## ALERT SERVICE BULLETIN

**206-24-144**

**MODEL AFFECTED:** 206A/B and TH-67

**SUBJECT:** SWASHPLATE OUTER RING AND COLLECTIVE LEVER, CLEARANCE CHECK OF

**Figure 1 - Collective lever assembly - clearance check**

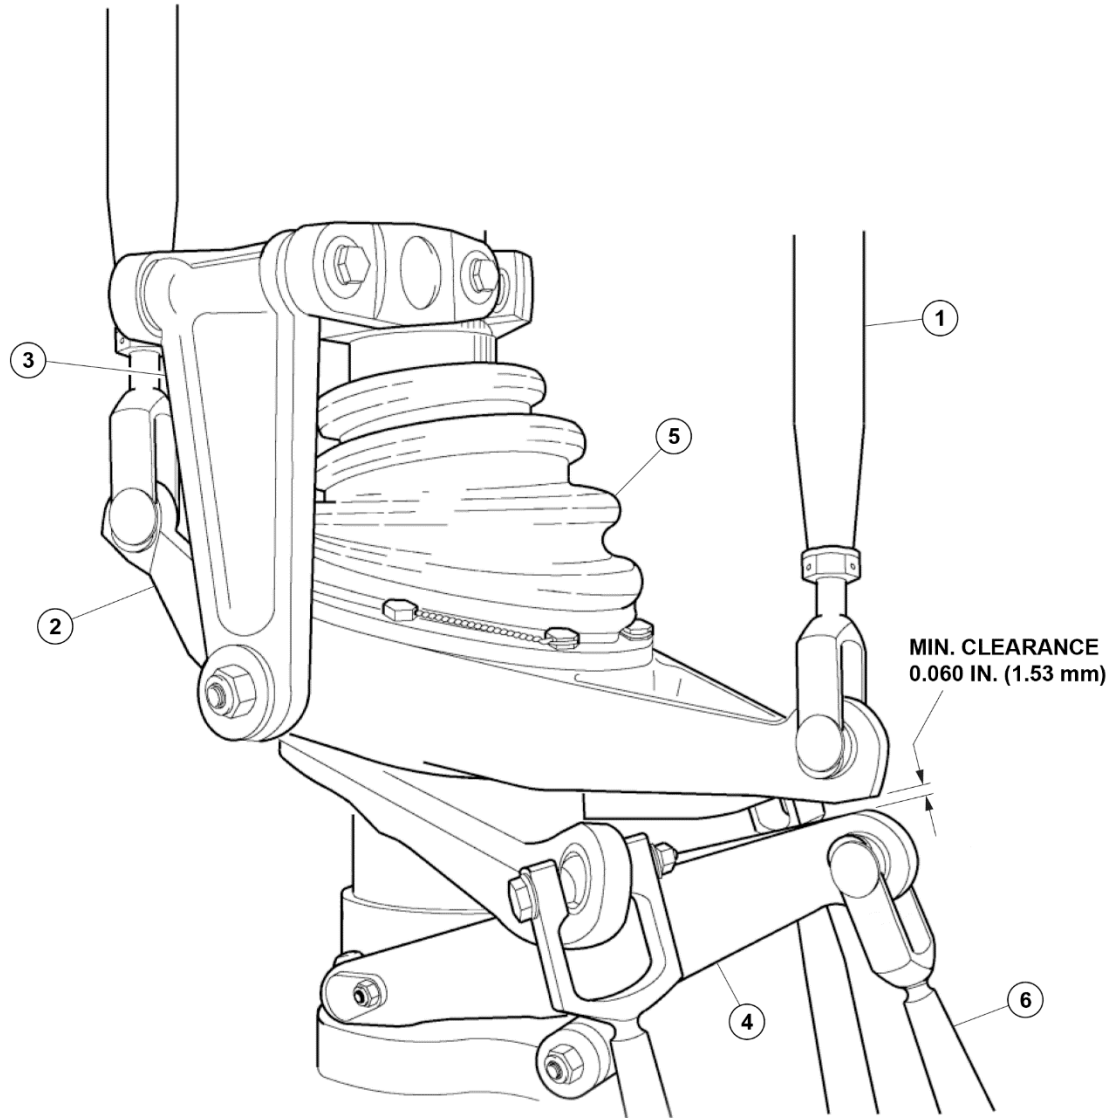
7. Slowly rotate the swashplate outer ring (2, Figure 1) until one of the pitch link attachment points is directly over the collective lever assembly (4).

8. Measure and record the clearance between the collective lever assembly (4) and the swashplate outer ring (2).
9. Repeat steps 7 and 8 for the second pitch link attachment point.

10. If clearance is 0.060 inch (1.53mm) or more at both pitch link attachment points, go to step 12.
11. If clearance is less than 0.060 inch (1.53 mm) at one or both pitch link attachment points, rigging of the collective and cyclic flight controls (BHT-206A/B-SERIES-MM, Chapter 67) is required prior to next flight.

- a. If minimum clearance of 0.060 inch (1.53mm) cannot be achieved at both pitch link attachment points after collective and cyclic controls rigging, it is acceptable to adjust the length of collective link 206-001-024 or 206-001-189 (6). Tolerance for rigging dimensions of the collective lever must be maintained (BHT-206A/B-SERIES-MM, Chapter 67 and Figure 2).
